# **West Linn OR 43 2016 Conceptual Design Plan**

## Technical Appendices

## **Hwy 43 conceptual plan refinement – Metro comments 6/12/15 (John Mermin, Lake McTighe, Anthony Buczek and Tom Kloster)**

Subject: **Draft OR43 Refinement Concept Plan for City of West Linn**

**Figure 2: Willamette Drive Proposed "Ideal" Cross Section**

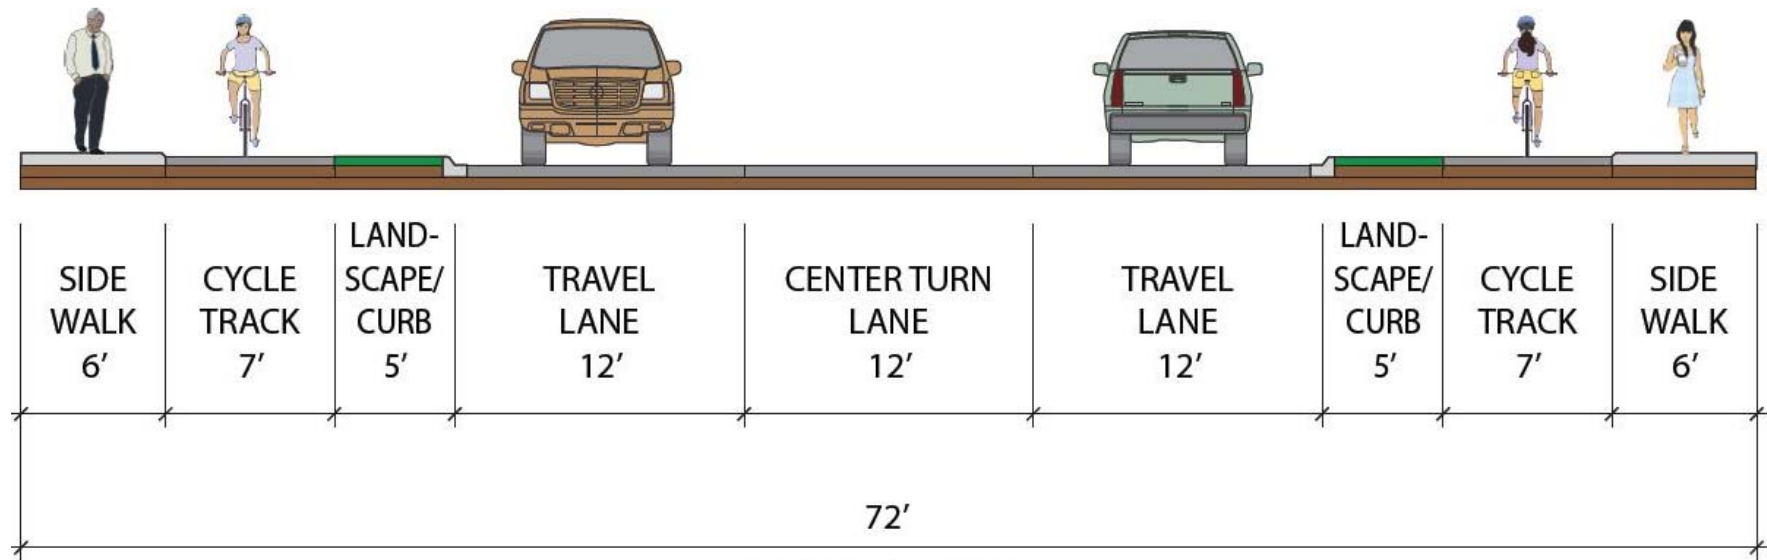
The proposed alignment shows space narrowed for biking and walking facilities but not for autos. Instead of using 12 feet for a center turn lane, use that width for a landscaped buffer for biking and walking. Also, similar to the comment above, 10 ft travel lanes are sufficient.

4. Proposed OR43 Cross-Section: The proposed typical highway cross-section is too narrow for the various functions.
5. Design Exceptions: Design exceptions will be necessary to gain ODOT approval for several elements of the concept plan cross-section as currently presented. We recommend that several of those elements be changed to meet or exceed standards. For the design elements expected to need design exceptions, we recommend that we continue to work together to gain design concurrence. Design concurrence would result in coordination with our Salem office to determine which design exceptions will likely not be supported and which can be supported. The elements needing design exceptions are:

curbs and accommodation for storm drainage. ODOT will not support 11-foot travel lanes in curb-tight segments without a shoulder. Placing the curb next to the travel lane places the motor vehicle tires in the area where water collects potentially resulting in water splashing cyclist and pedestrians or the car hydroplaning. If the 12-foot travel lane width is retained more inlets or other design considerations need to be made in order to avoid water on the highway.

- c. Raised bike lane width: The constrained cross-section shows six-feet for a raised bike lane. Six-feet is too narrow for the raised bike lane given a portion of the 6-feet is used for the grade/slope transition. We recommend this concept have the bike lane at the same level as the surface of the roadway or at the same level as the sidewalk in order to provide a continuous shared-use path. While a 10-foot wide shared-use path would satisfy the minimum width guidelines, we don’t think this is the best solution because there is the potential for local cyclist to use one-side of the highway to go both directions. Please consider providing a wider area for this reason. Consider adding a 2-foot utility strip for utility poles, signage and signal poles allowing the minimum, ADA clearance of 4-feet. Related additional discussion is below. Also, how mail delivery will work and the placement of mailboxes need consideration. There is a potential for mailboxes to create another obstacle in addition to street signage.

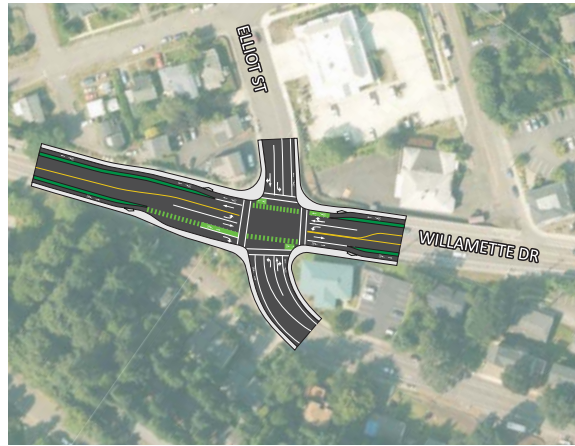
6. I-205 Interchange: A much larger discussion is needed. It is likely that resolving the I-205/OR43 interchange is beyond the scope of this project. The queuing from the Arch Bridge and ramp meters would need a VISSIM analysis to model the operations of the area accurately. Any modification to the ramp terminals may affect the weaving issues on I-205 where VISSIM or other tools will help us understand the tradeoffs and other 'domino' factors when modifying the area.

The queues from the Arch Bridge, the ramp meters and the McKilliken/Hood signal may impact the performance of the roundabouts where traffic signals may work better under these queuing conditions.

### Challenges

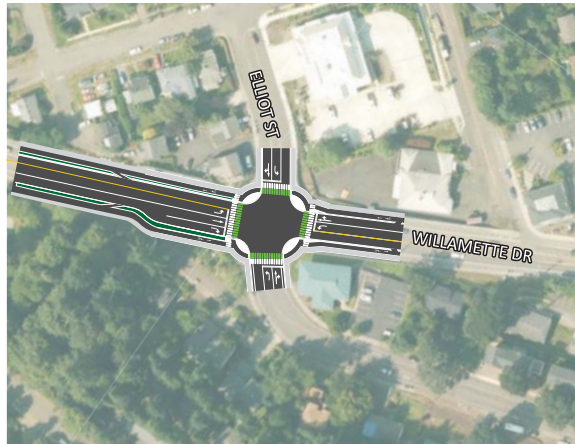
Transit is not shown --- this MUST happen at the conceptual level

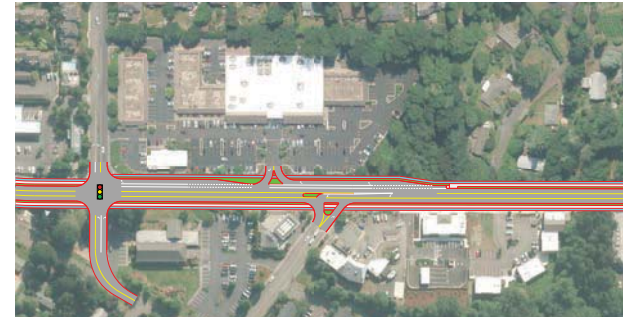
**Must show how transit functions!**

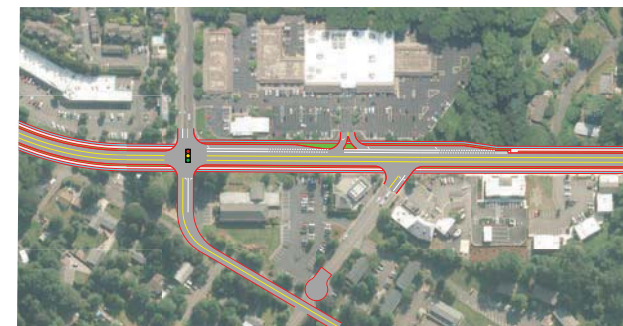
**Must Show Transit!**

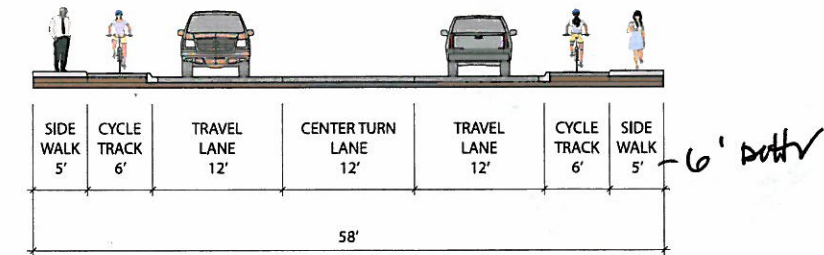
INCREASE DRAINAGE? GREAT TO HAVE TURN LANE.

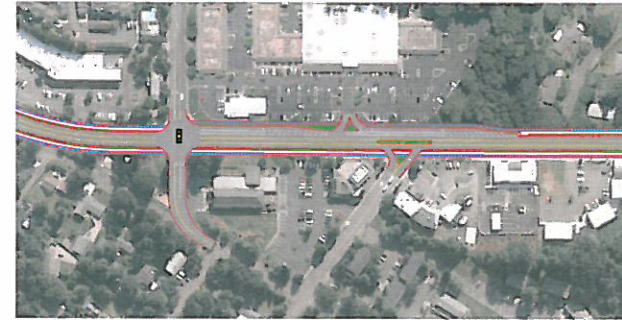
Consider #3 - on/off ramps adjacent like Oregon City

#### Constrained

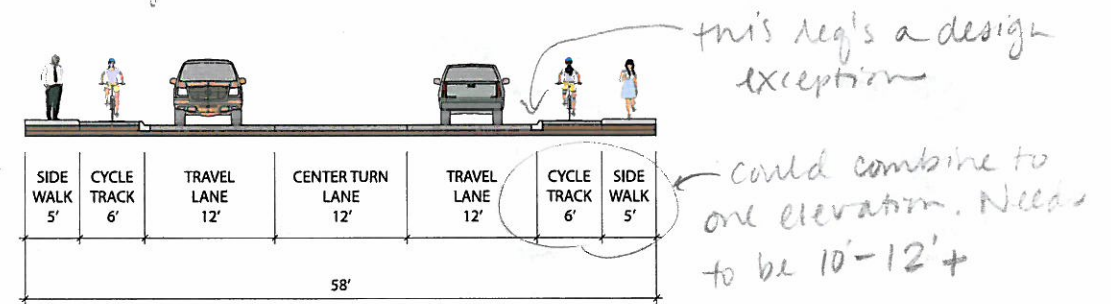
12' lanes is constrained in heavy rain storms. Need more inlets.

## Roundabout Concept #1

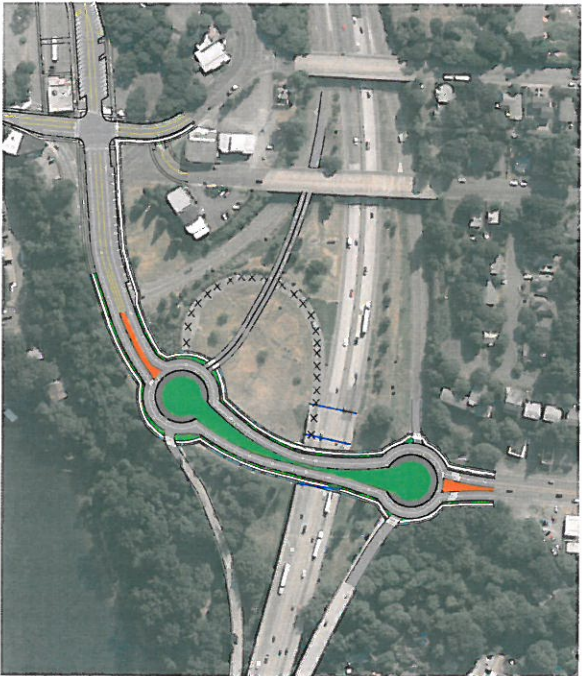
Bike/Ped - NORTHBOUND - BRIDGE  
TO OVERCOME STEEP GRADES +  
illegal camping issues

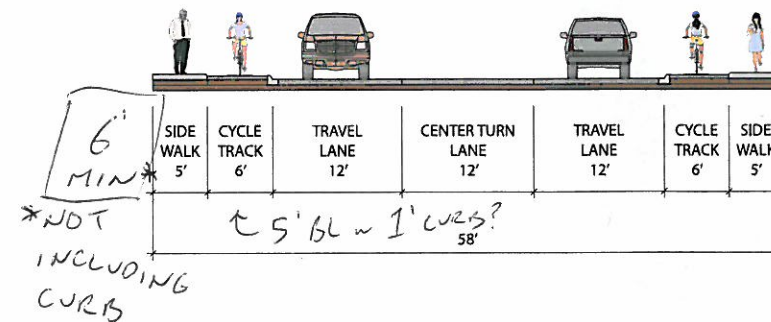
BOTH OPTIONS - MAKE CYCLE TRACK + SIDEWALK SAME ELEVATION TO IMPROVE FLEXIBILITY OF SPACE + EASE OF MAINTENANCE USE PAVEMENT STAMP OR TEXTURE TO DIFFERENTIATE?

## Roundabout Concept #1

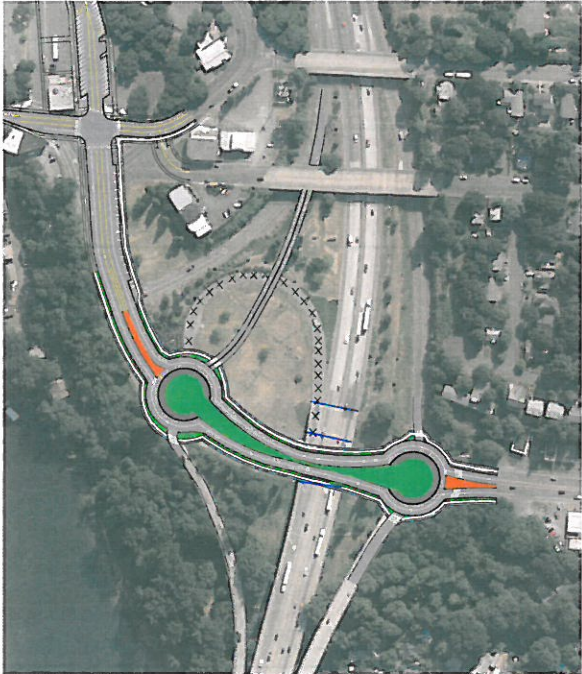
GRADE SEPARATED CROSSING  
OF RAMP
